# UNITED STATES PATENT AND TRADEMARK OFFICE

10/576,258

<b>Office Action Summary</b>	<b>Application No.</b> 10/576,258	<b>Applicant(s)</b> MASAMURA ET AL.	
	<b>Examiner</b> MARINA TIETJEN	<b>Art Unit</b> 3753

## **DETAILED ACTION**

FIG. 2

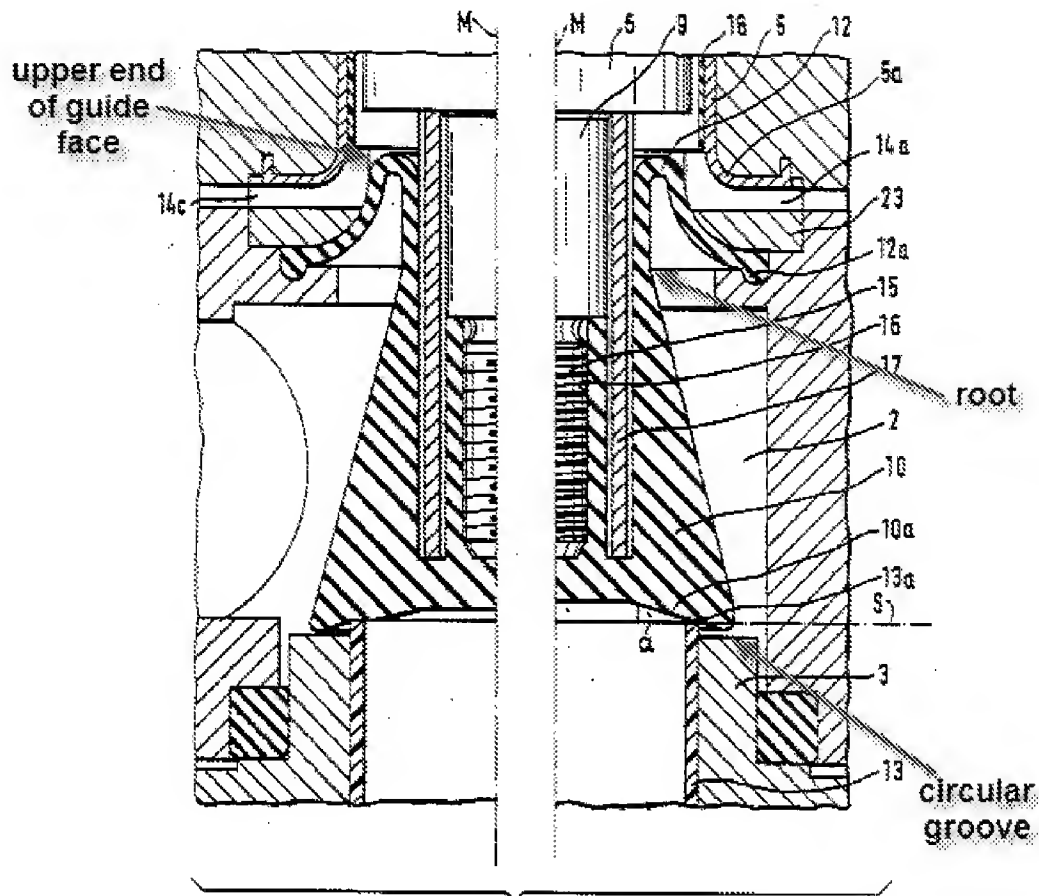
a diaphragm part (12) formed extending in a curve, radially from the main body (10), the diaphragm part (12) forming substantially a 270° arc in the valve-opened state (diaphragm part "rolls" and preserves shape shown in fig. 2, while bringing tapered surface of 10 vertically upwards, thereby forming substantially a 270° arc; col. 3, line 54), and including a root (where 12 merges with 10, see labeled fig. 2 below) connected to the main body (10) and positioned inside the diameter of the valve seat (13); and

a fixed part (12a) formed at an outer peripheral edge of the diaphragm part (12) and held at a position higher than the root (substantial portion of fixed part sits above root) during the valve-closed state;

wherein the diaphragm valve element (10, 12) in which the diaphragm part (12) having a thin wall and the fixed part (12a) having a thick wall are formed so that respective upper surfaces are flush with each other, and the fixed part (12a) is held between a lower fixing face (of body 1) and an upper fixing face (of 23) which extends to the diaphragm part (12);

a guide face (see labeled fig. 2 above) having a slope contiguous from the upper fixing face (of 23) above the diaphragm part (12) so that the diaphragm part (12) comes into contact with the guide face (fig. 2 above) when the diaphragm valve element (10, 12) is separated from the valve seat (13);

wherein the root (fig. 2 above) substantially vertically extends upward from the main body (10);

a circular groove (see labeled fig. 2 above) formed around the valve seat (13), wherein the first flow passage (Z) is in communication with the circular groove (fig. 2 above) formed around the valve seat (13).
